**RE: ITB No. 21-105, N.E. Expressway Frontage Road Multiuse Path Project**

**ADDENDUM NO. 2**  
**Invitation to Bid, No. 21-105**  
**N.E. Expressway Frontage Road Multiuse Path Project**  
**REVISED 5/11/2021**

SPECIAL DESIGN DECORATIVE FENCE

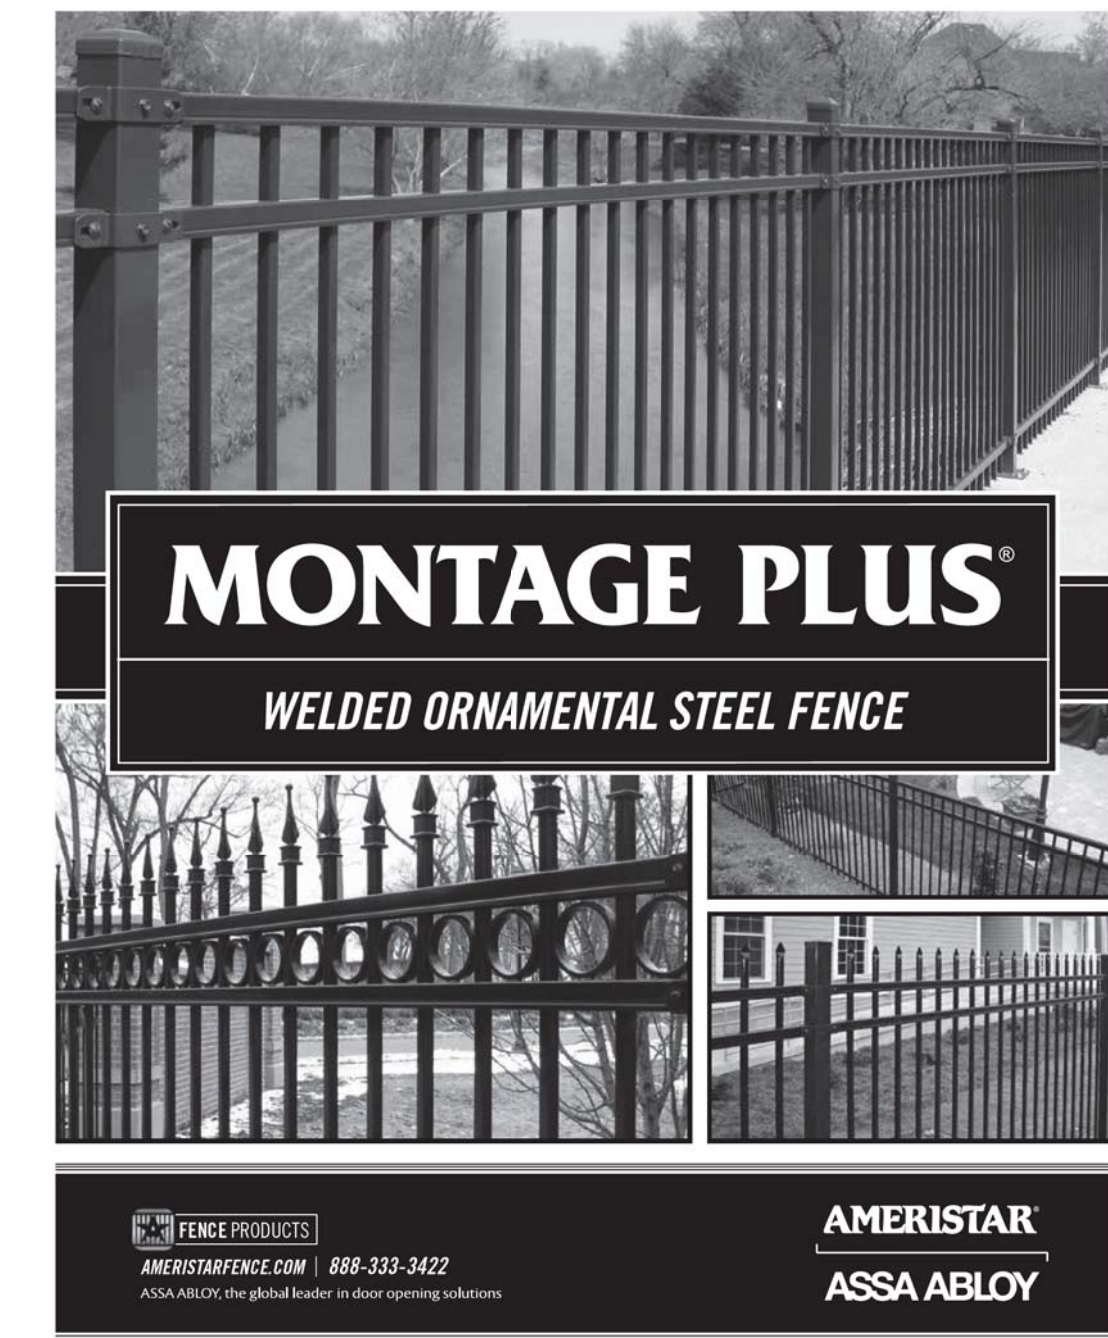
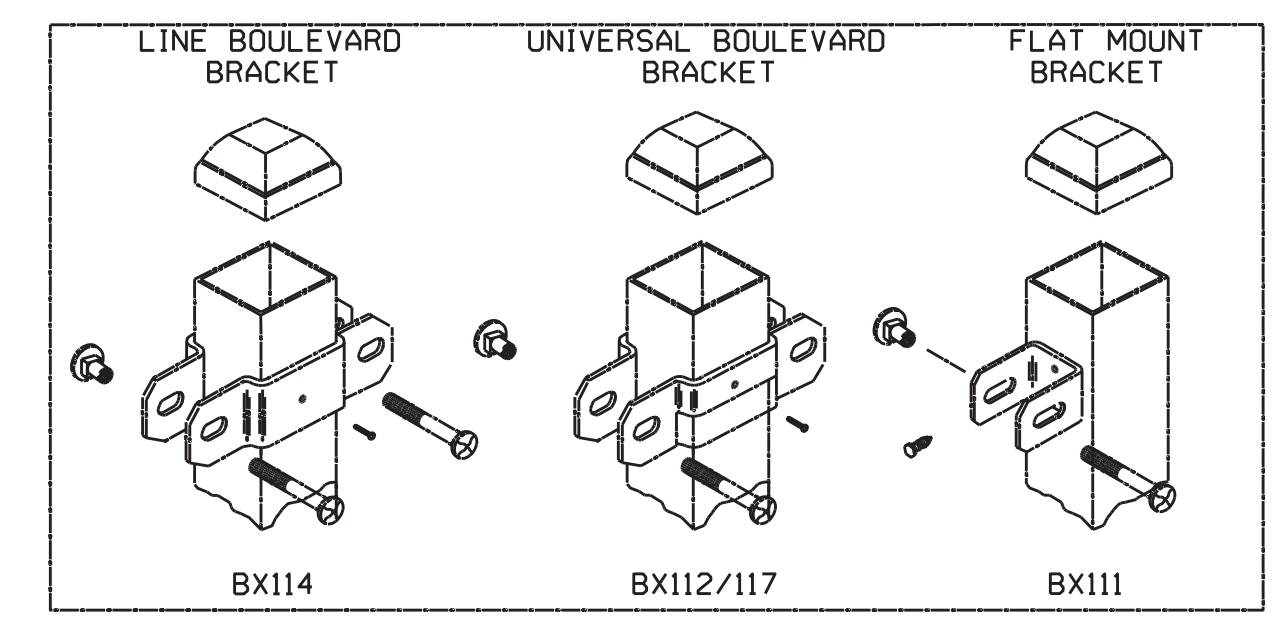
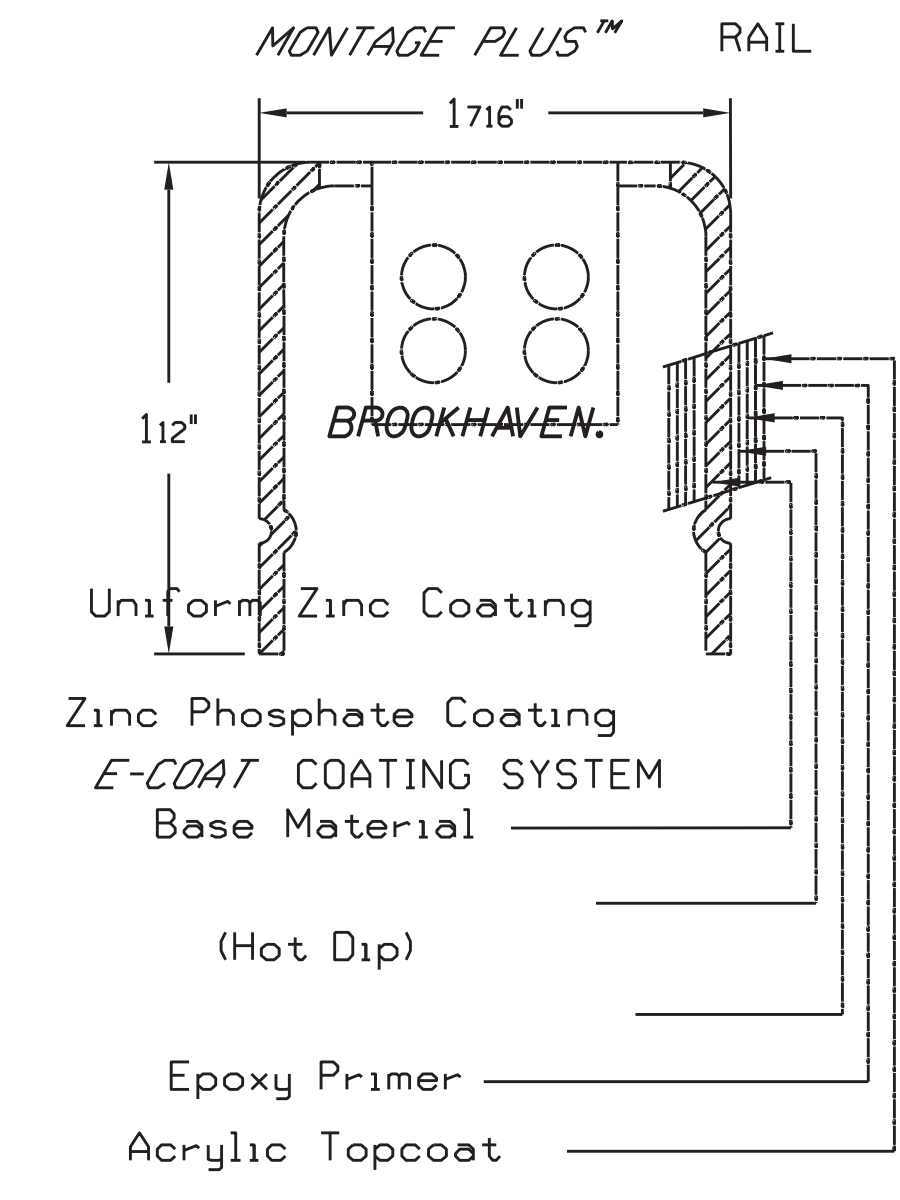
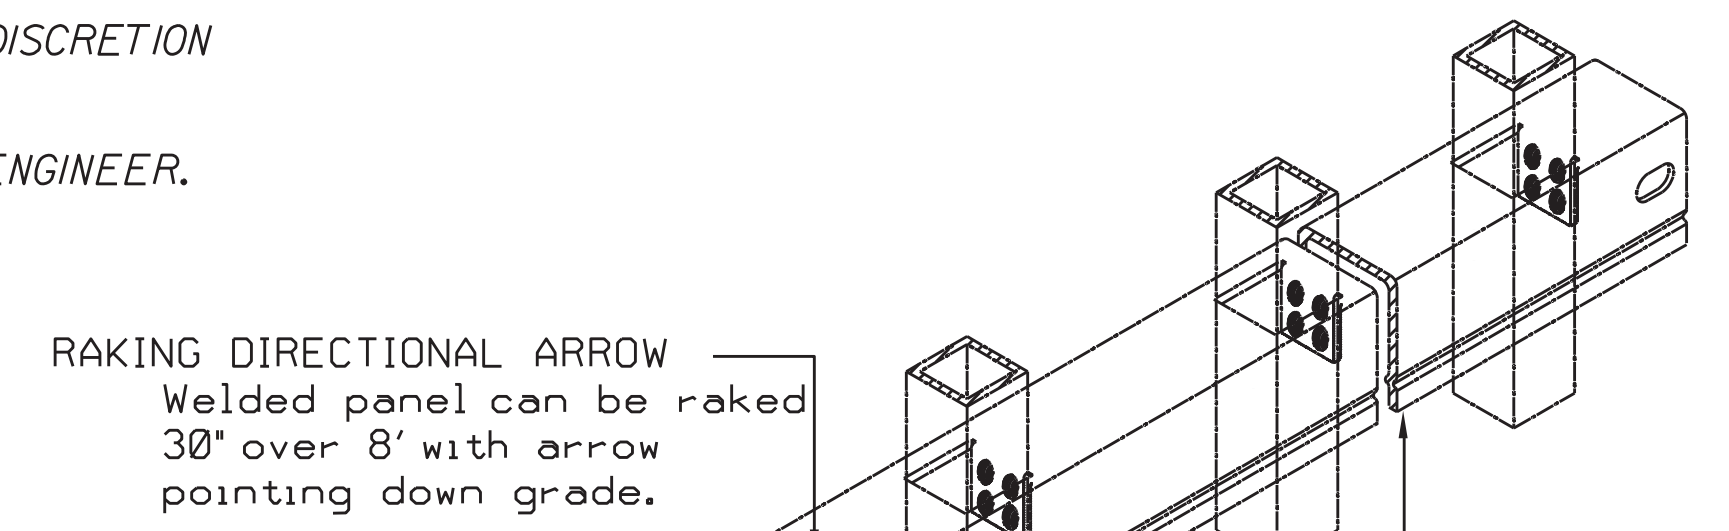
- A. The following are additional and updated questions received and City of Brookhaven responses for the above- referenced solicitation:
1. Can you clarify if the line item 515-1000 FALL PROTECTION FENCE FOR WALL #1, SPCL DESIGN (Per City of Brookhaven Details) is the same decorative railing panels as shown in drawing 32-001? If so, will the city provide the panels and will the contractor include the posts and install the panels?  
**Contractor to provide fence / rail quote based on the attached detail as opposed to panel shown on sheet 32-001. (See Attachment)**

NOTE: STYLE AND PANEL OPTION AT THE DISCRETION OF THE CITY OF BROOKHAVEN. AN EQUIVALENT PRODUCT MAY BE SUBMITTED FOR APPROVAL BY THE ENGINEER.
